Re: USACE File No. NAE-2019-02150
Remedial Activities Project
Former Tidewater Facility
200 Taft Street
Pawtucket, Rhode Island

As we have discussed during the past few weeks, GZA GeoEnvironmental, Inc. (GZA), on behalf of The Narragansett Electric Company d/b/a National Grid (National Grid), is seeking approval of certain modifications to the approved, on-going Remedial Activities at the Former Tidewater Facility located in Pawtucket, Rhode Island (herein referred to as the Site).

Given the observed coal tar impacts in certain areas, we are seeking approval to modify the revetment cap design in the northern portion of the Site between Stations 4+00 and 5+95 (approximately 195 feet along the shoreline) to minimize the disturbance of coal tar impacted soil and the risk of a potential breach in the controls (turbidity curtains and absorbent booms) installed within the river. Instead of disturbing and excavating in these impacted areas, fill consisting of stone, RCM, woven and non-woven geotextiles, and riprap will be placed on top of the surface of the impacted sediment, all below MHW and the High Tide Line (HTL). The slope of the bottom sediment will also be adjusted accordingly –

PROJ MGR: DJR	REVIEWED BY: MJP	CHECKED BY: DJR
DESIGNED BY: ---	DRAWN BY: SAB	SCALE: AS SHOWN
DATE: JANUARY 2022	PROJECT NO. 43654.40	REVISION NO.
		DRAWING S-65A SHEET NO. 25 OF 74

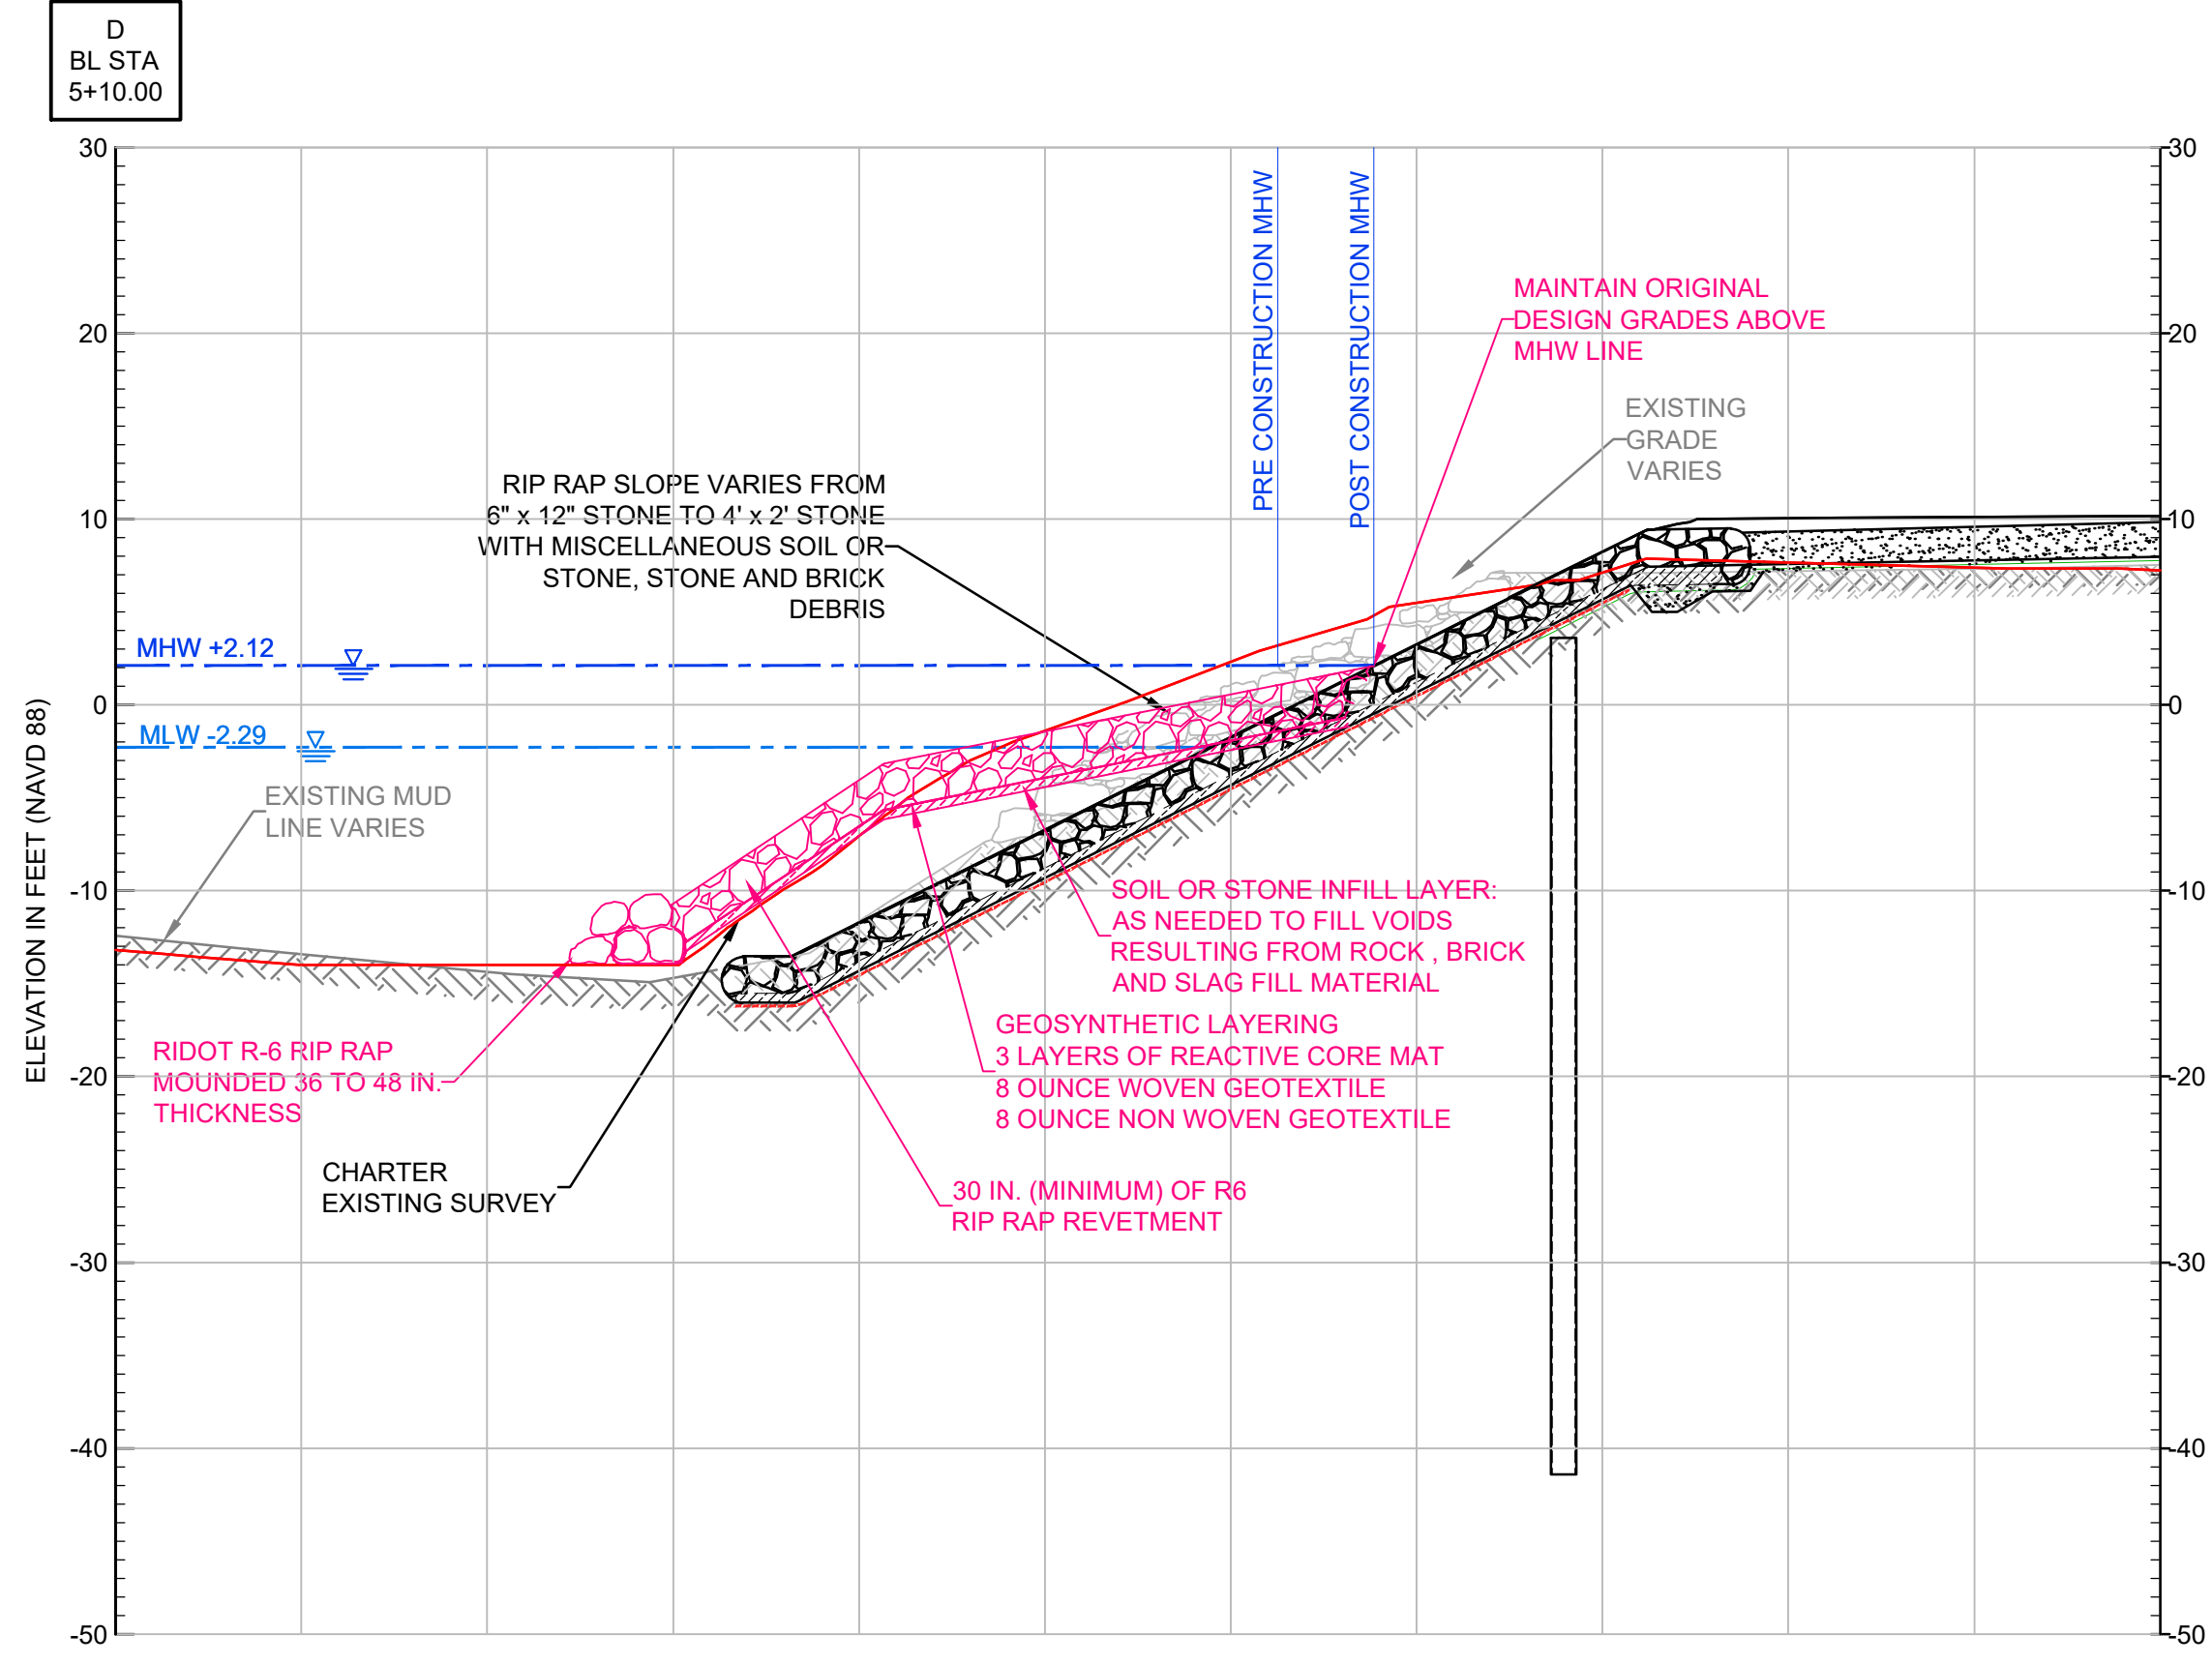
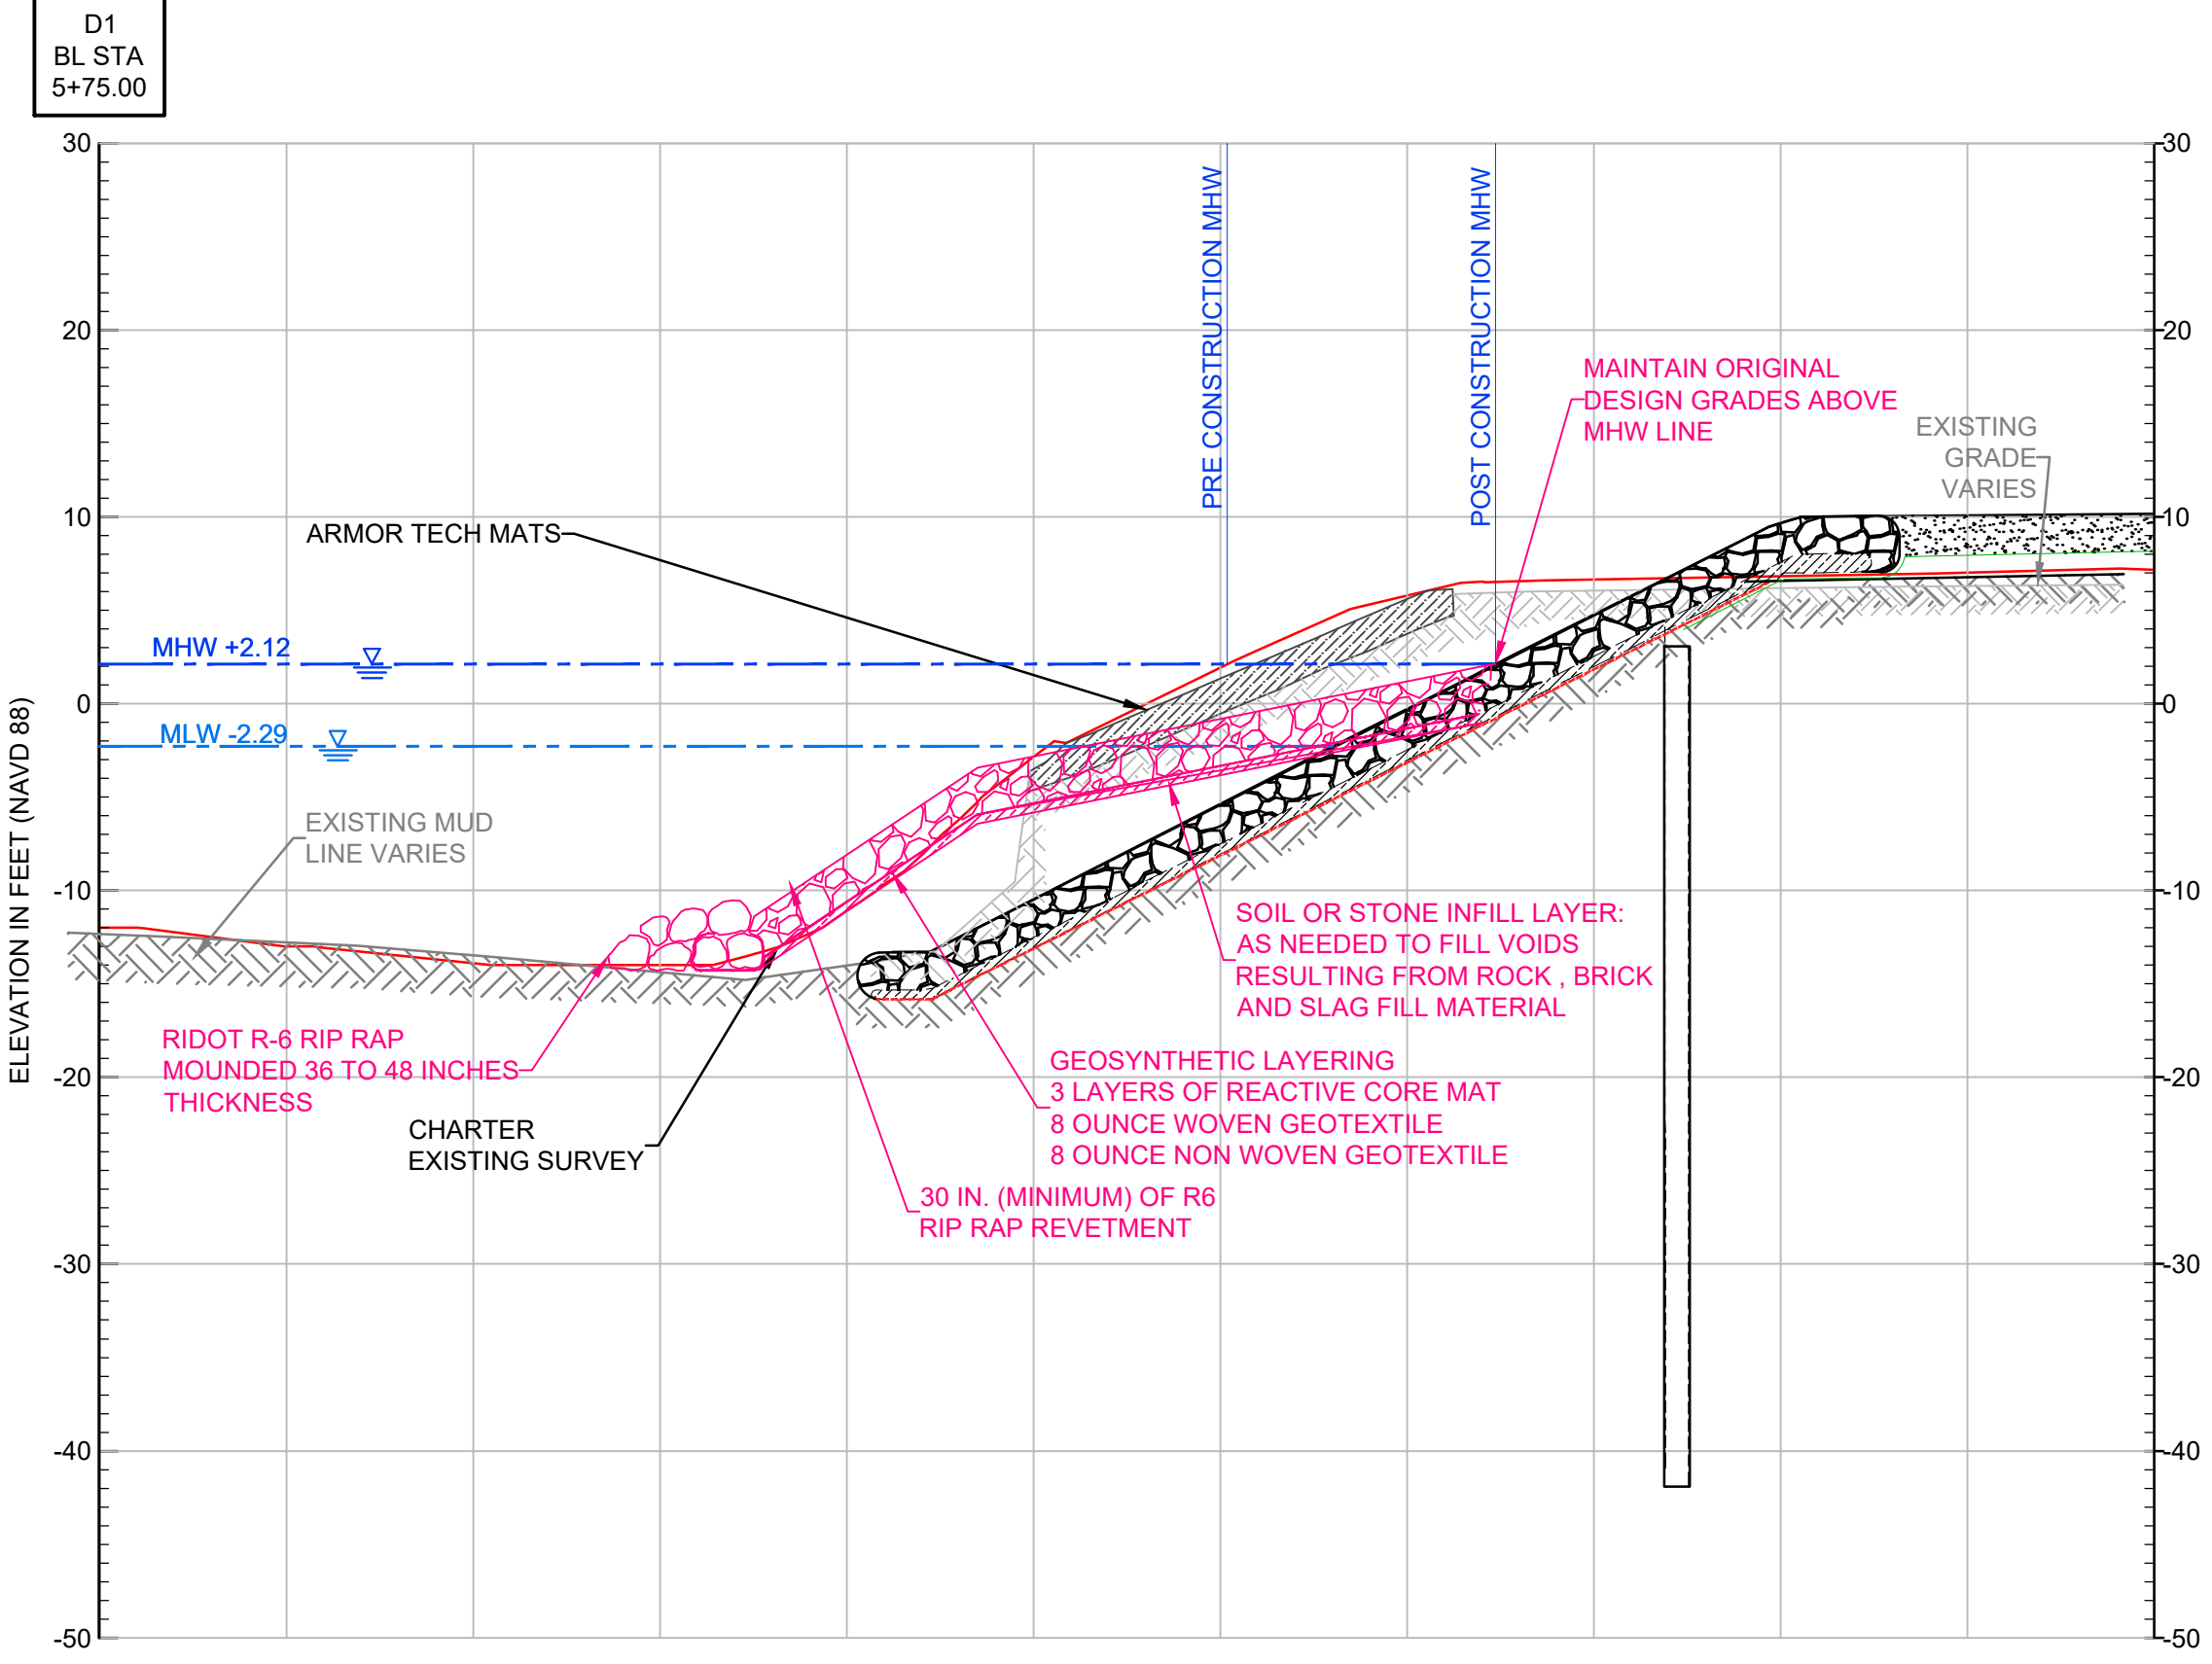
extend several feet beyond what was anticipated within the 2019 permit. The existing riverbank above MHW will be regraded consistent with the original permitted design. The final result for the overall project will be a decrease in the amount of dredged material and an increase in fill replacement compared to the approved permit values. Approximate areas and distances are as follows:
